State of California
AIR RESOURCES BOARD
Executive Order G-70-36-A

Relating to the Modification of the
Certification of the OPW Balance Phase II
Vapor Recovery System for Service Stations

IT IS ORDERED AND RESOLVED: That the certification, Executive Order G-70-36 issued on April 13, 1979, for the OPW balance Phase II vapor collection and disposal system is hereby modified to eliminate the previously allowed use of a single OPW 78 series recirculation trap on dual dispensers dispensing the same product from both sides. The system hereby modified is certified to be at least 90 percent effective in self-serve use and at least 95 percent effective in attendant use at gasoline service stations in conjunction with Phase I vapor recovery systems which have been certified by the Air Resources Board. Alternate piping arrangements for the system hereby certified are described in Exhibits 1 and 2 attached. A listing of certified system components is hereby presented in Exhibit 3 attached hereto.

EXHIBIT 2
Executive Order G-70-36-A
OPW Balance Phase II
Vapor Recovery System
Individual Vapor Return Lines

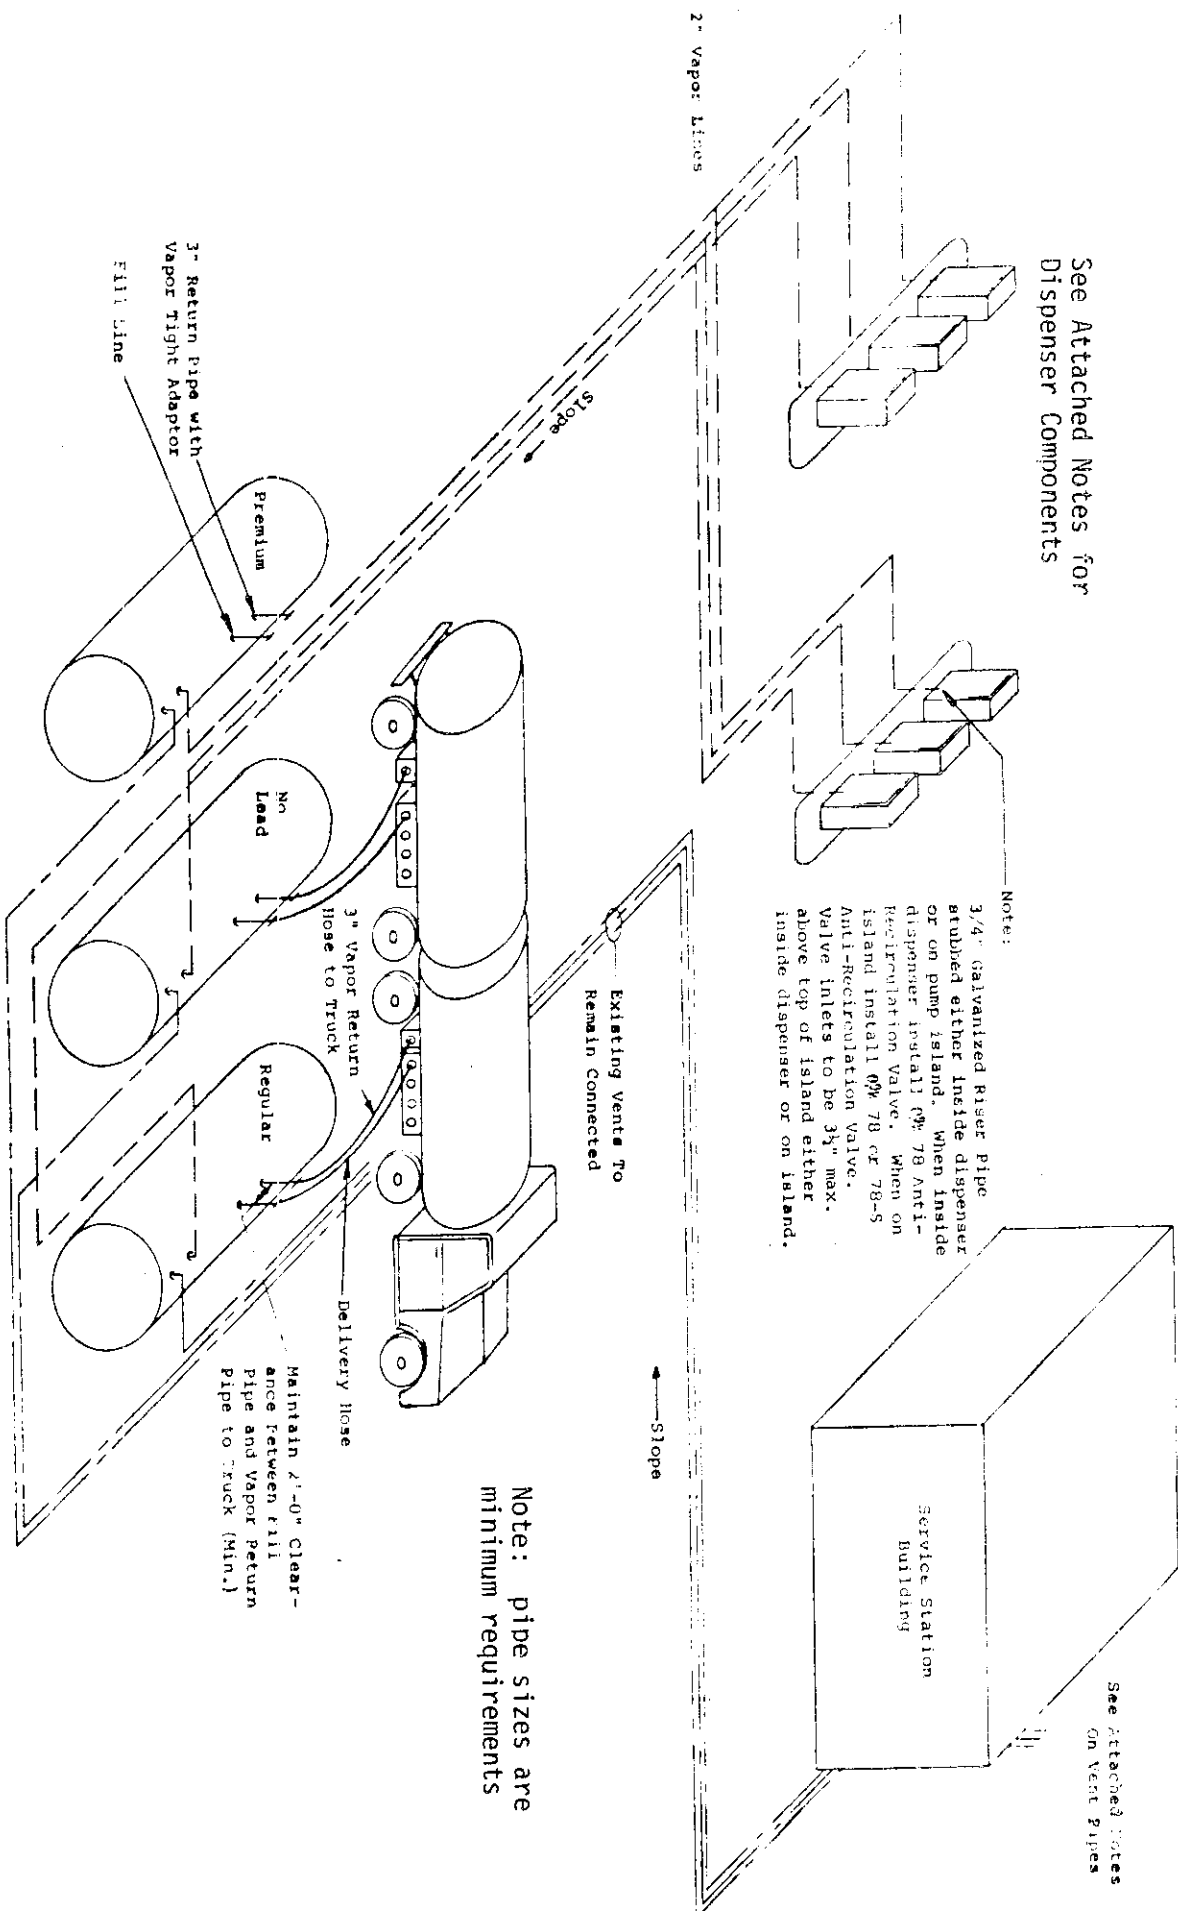
Note:
3/4" galvanized riser pipe
stubbed either inside dispenser
or on pump island. When inside
dispenser install 60% 78 Anti-
Recirculation Valve. When on
island install 60% 78 or 78-5
Anti-Recirculation Valve.
Valve inlets to be 3 1/2" max.
above top of island either
inside dispenser or on island.
